Delegated Report

Application No: 20260160

Location: Land On East Side Of Dean Lane, Harvel, Gravesend

Description: Application for the approval of condition 6 (Materials), condition 7 (Drainage for parking), condition 8 (Soft Landscaping), condition 12 (Hard Landscaping), condition 13 (Drainage), condition 14 (Ecological Scheme) and condition 15 (Lighting) attached to planning reference number 20250521.

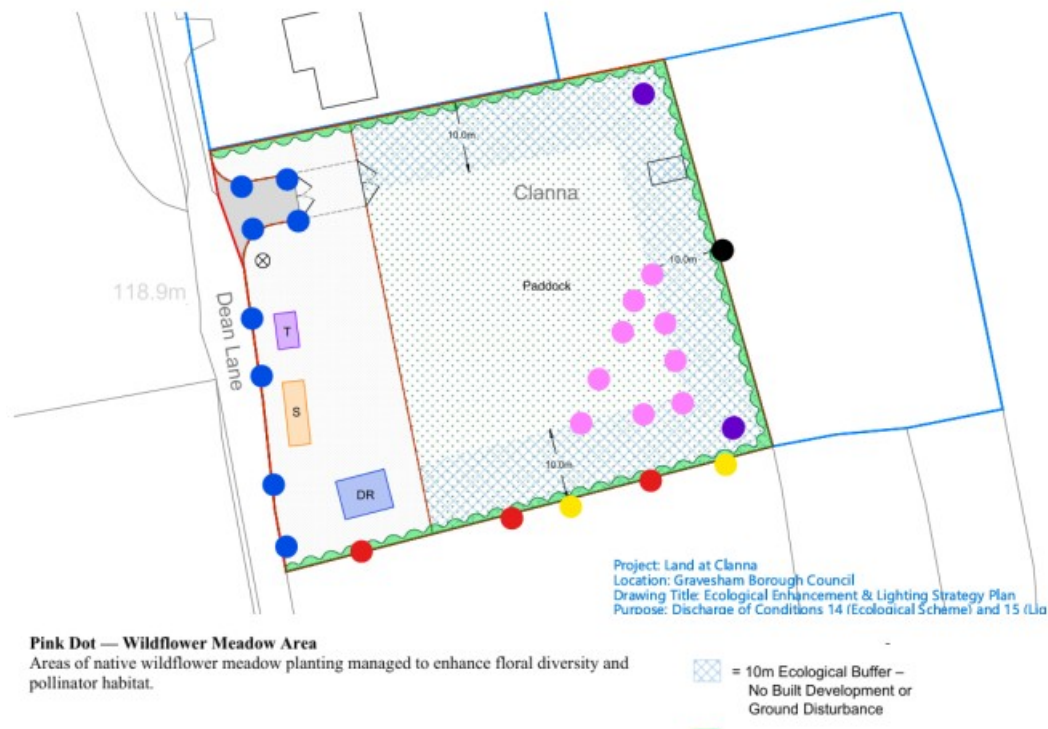
It is not clear from the submitted information where reinforcement planting is occurring nor in what density, nor the relative proportions (percentage composition) of each of the following species:

This information should be provided in advance of condition discharge and links to the requirements of condition 8.

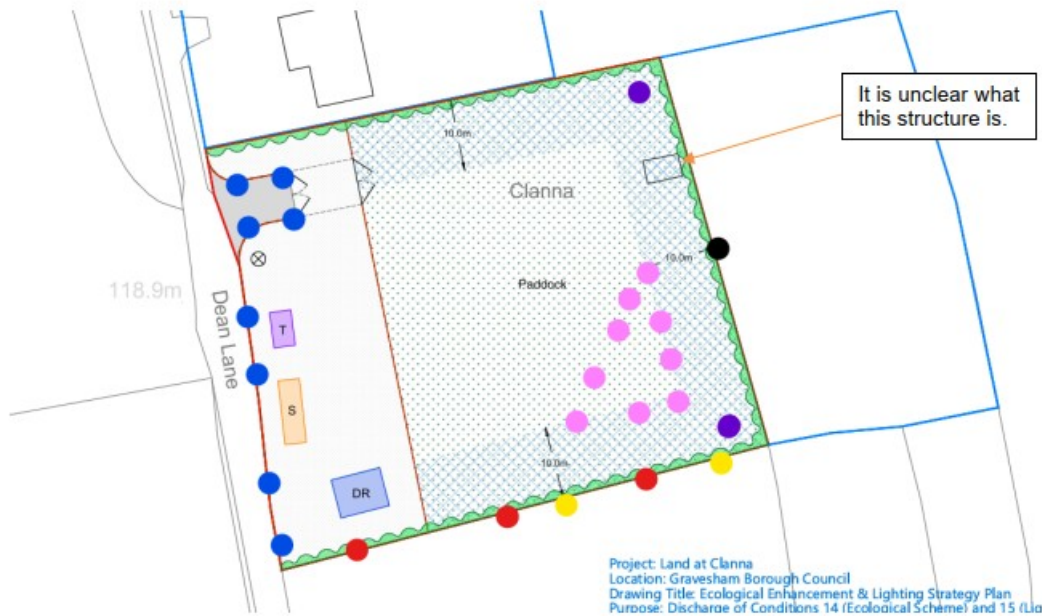
We note that a gate and structure appears to be proposed/present within the ecological buffer zone. This is likely to be inappropriate. The gate into the ecological buffer zone will allow horses to likely erode the habitat in this area, particularly in wet weather. The submitted information also indicates that there will be no disturbance or development in the ecological buffer zone, yet there appears to be a structure in this area (a stable/horse shelter?).

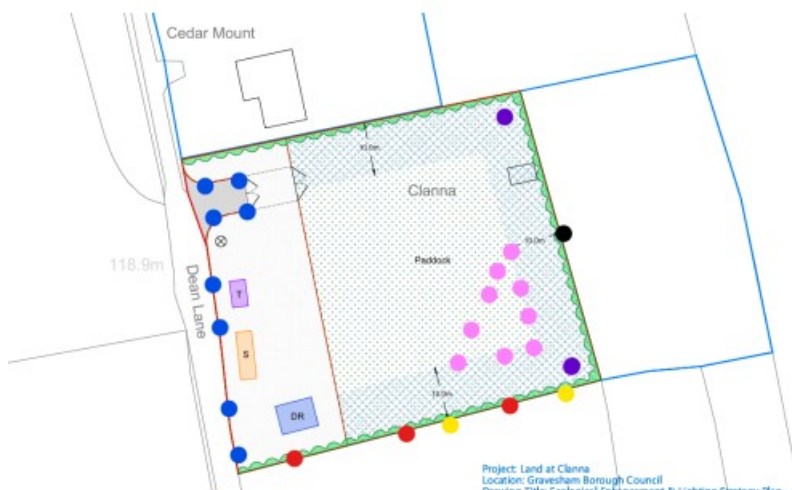
Details on the rough locations of bat and bird boxes have been provided. However, confirmation needs to be provided that the bird and bat boxes will be installed on a mature or semi-mature tree at 3-5m height. If no mature trees are available, it will not be possible place any bird boxes around the paddock area, the boxes will need to go on a structure to the west of the site. Bat boxes would need to either go on a structure to the west of the site, or be pole mounted in the locations specified.

There also needs to be a clear flight path to and from the boxes. Bird boxes will need to face north or east, and the bat box face south. The make and model of the bird and bat boxes need to be provided, and the boxes should be made of woodcrete for longevity and to protect against squirrel damage. The bird boxes should be targeted at appropriate species of conservation concern. We recommend starling or house sparrow boxes. This information needs to be specified in the submission material.

Hedgehog Passages

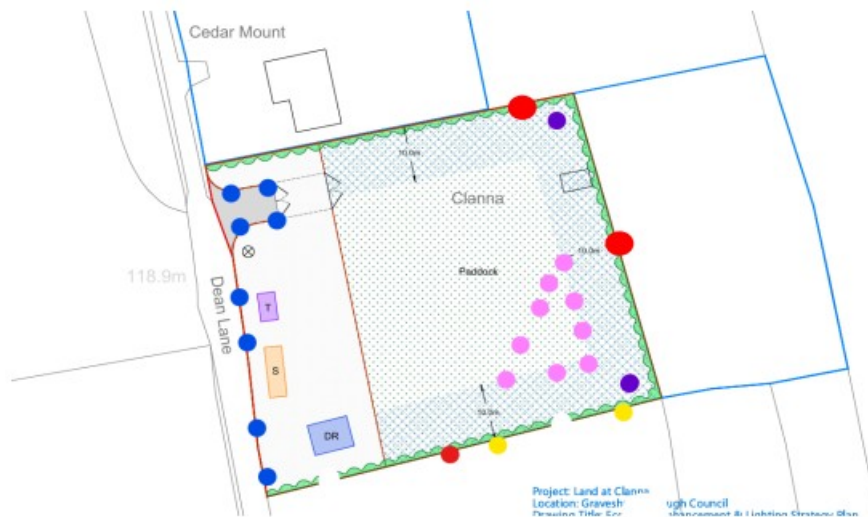
We note that a plan has been provided to show the locations of 13x13cm hedgehog passage points. We note that these are all located along one side of the development.

We would recommend instead that one gap be provided in the southern, eastern and northern fencing as shown below. This will maximise hedgehog passage to adjacent habitat:

Blue Dot — Wildlife Sensitive Lighting

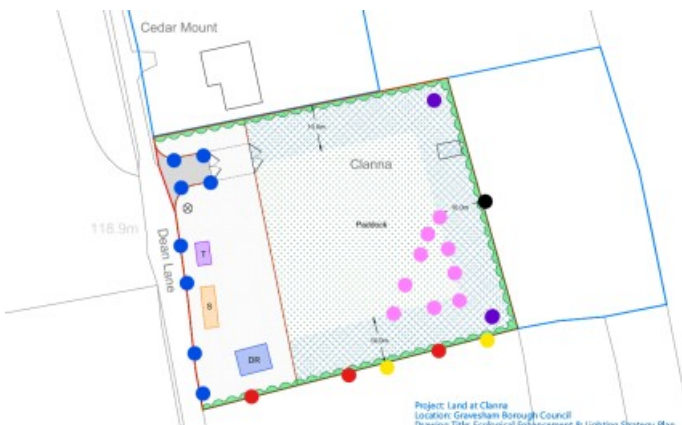
We note that the proposed positions of lighting has now been provided:

We note that no lux level contour plan has been provided. This would rely on understanding the exact luminaire specifications at this stage. We request that this information be provided to allow us to better understand the potential impact of proposals.
